# Tree Impact Assessment

## Croydon Community Wellbeing Precinct

Version 4 (29 November 2024)  
Tree Logic Ref. 012527

Including addendum for 1 Civic Square,  
Croydon 3136 (2 April 2025)

**Figure 2:** Locations of proposed root barriers (purple lines) overlaid onto Site Plan.

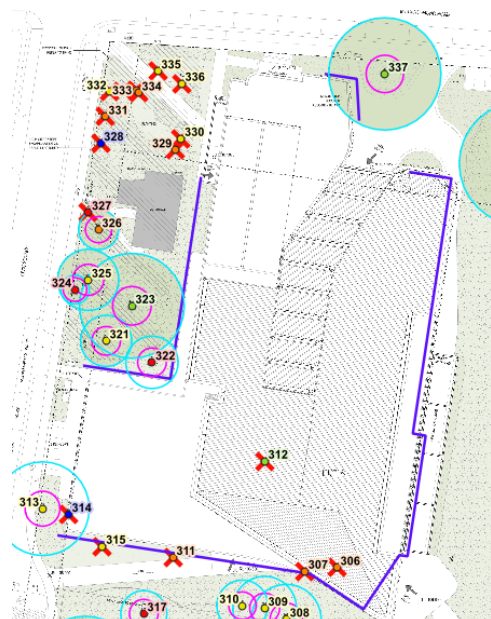
The plan at Appendix 2 includes the trees' TPZs and Structural Root Zones (SRZs) and shows where encroachments have been identified from the design plans reviewed. Two of the trees intended to be retained (Nos. 313 and 337) would have built form extending into their TPZs while intrusions for other trees would primarily come from drainage lines and root barriers that it is understood are proposed to protect the new building from the effects of potential future root growth. Concept root barrier locations and drainage lines are shown on the plan extracts at Figure 2 and Figure 3 respectively.

- **Trees 305, 308, 309 and 310** would be impacted by the proposed drainage alignment. Relocating the drainage to impact none or only a minor proportion of their TPZs would appear feasible. Otherwise, the feasibility of boring below the rootzones would need to be investigated.
- **Tree 313** would also have its TPZ most affected by proposed drainage. Boring drainage lines below the root zone would reduce intrusion to approximately 14% from the building footprint. This tree, a *Melaleuca linariifolia*, would be expected to tolerate this level of intrusion.
- **Tree 322** is a small Cherry Plum (*Prunus cerasifera*) which is of little arboricultural merit. Design amendment would not be warranted to preserve this tree over providing a new replacement planting within the site.

- Tree 322 is of little arboricultural value and design amendment is not considered warranted to preserve its condition.
- To preserve trees 305, 308, 309, 310 and 313, proposed drainage alignments would need to be bored below the rootzones or amended to affect no more than 10% of the trees TPZs.

**Figure 3:** Extract from General Site Plan (Civil) with drainage indicated by blue lines.

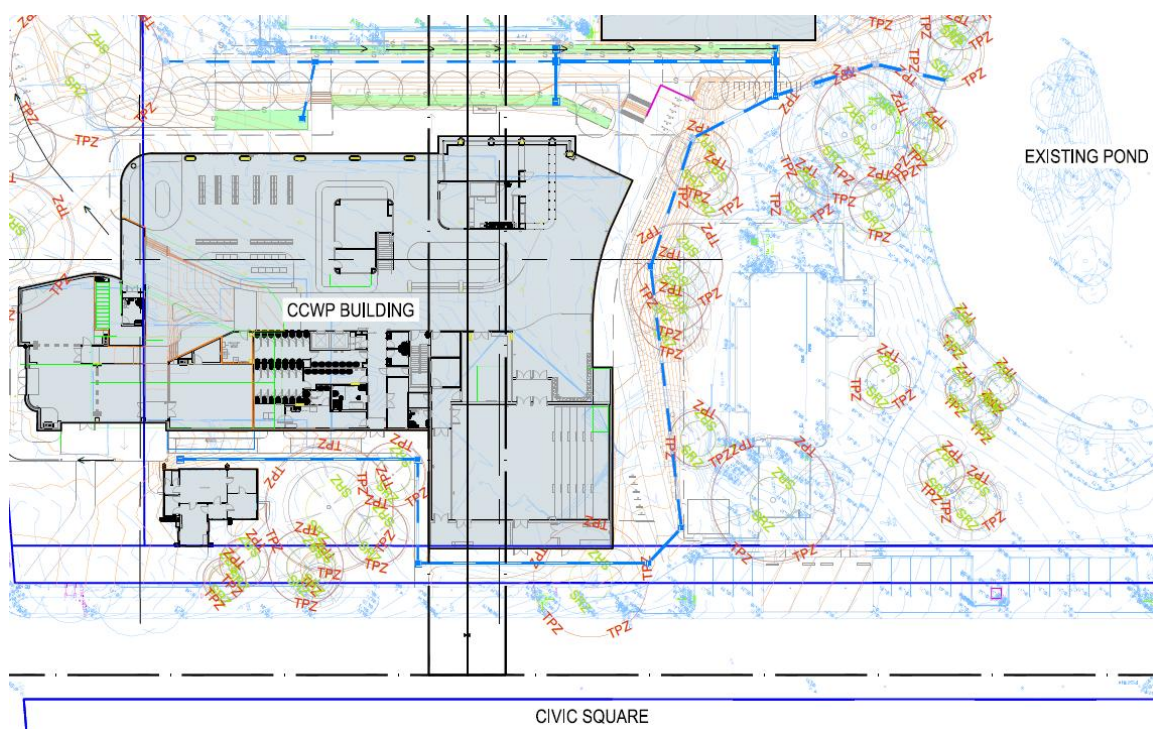
Twelve (12) trees have been identified from the supplied plans as having construction or trenching works proposed within their TPZs. Six (6) of these have encroachment calculated as being minor (less than 10% of their TPZs being impacted) while six other trees would be subjected to major TPZ encroachment. (Table 2).

*Extract from 'HV201/Existing & Proposed General Arrangement'*

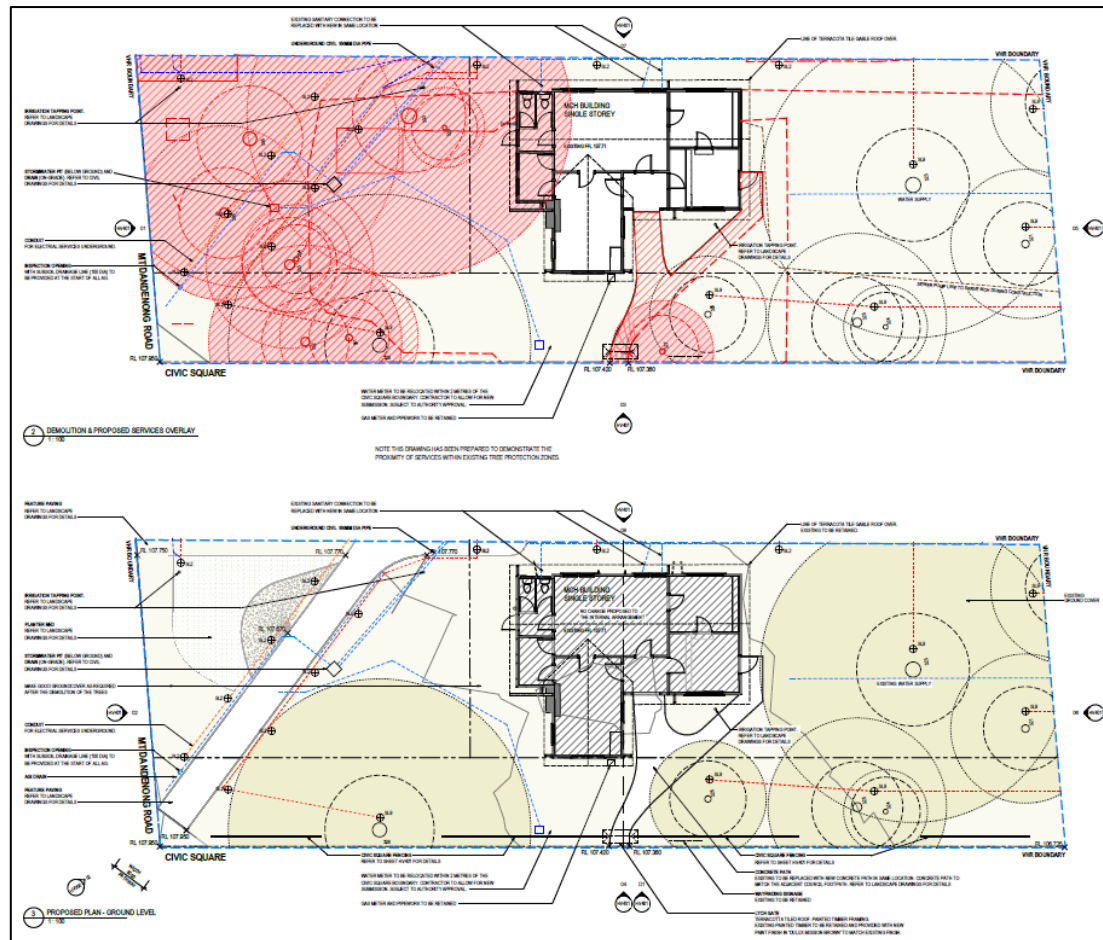
- Trees 328-336 occupy a high-profile part of the site (street intersection), this elevates their landscape significance. Together these trees afford considerable visual and noise buffering to the site, amongst other more generic amenity benefits (e.g. wildlife habitat, stormwater runoff reduction, mitigating the heat island effect...).

- Removal of Trees 322, 324, 327 is considered reasonable regardless of necessity based on their limited arboricultural rating and ULE.
- Retention of Trees 321-326 will preserve the bulk of landscape character in this section of the area, the loss of Tree 327 to facilitate access changes and new fencing is reasonable.

- Retention of Tree 328 will preserve moderate landscape character in this immediate vicinity, but removal of Trees 329-336 will significantly degrade streetscape character. Removal of all these trees is not justifiable based on their individual condition.

- The client has noted that 37% of the TPZ for Tree 330 is overlapped by heritage buildings, Tree 336 also has moderate overlap:
  - Roots have capacity to damage built form in two ways; directly (via thickening of roots beneath/against the built form, usually in/near the tree's SRZ), and indirectly (via localised soil drying/shrinking where reactive soils occur, in/near the tree's TPZ).

- Concerns regarding undesirable site use and public safety in this Civic Square space (as indicated by the client) may be mitigated via removal of most trees here, but it may be feasible to instead conduct targeted canopy thinning and/or greater uplift pruning and/or strategic tree removal to achieve this objective (e.g. removal of Tree 331 would enhance an open aesthetic on this frontage).

- Where tree protection zones conflict with proposed works, realignment of works and/or utilising low-impact options can often avoid the need for tree removals (e.g. the client has recently refined Civic Square fence locations to avoid the SRZ of Tree 328).

- Removal of existing steel post/wire fencing is expected to have negligible tree impacts if conducted with care/supervision within the TPZ of a retained tree (e.g. Tree 328).
- Proposed fencing is also considered a relatively low-impact style of construction – posts and above-grade infill minimise soil/root disturbance.
- Fence location has been refined to avoid the SRZ of retained trees where possible (e.g. section to east of Tree 328 now removed). Fencing does still encroach the perimeter of the SRZ for Tree 326, and the TPZ of Trees 325 & 328.
- Fencing post holes must be dug by hand where they are within a TPZ and relocated if large/structural roots are encountered (e.g. 50mm diameter for Trees 325 & 326, and 70mm diameter for Tree 328).
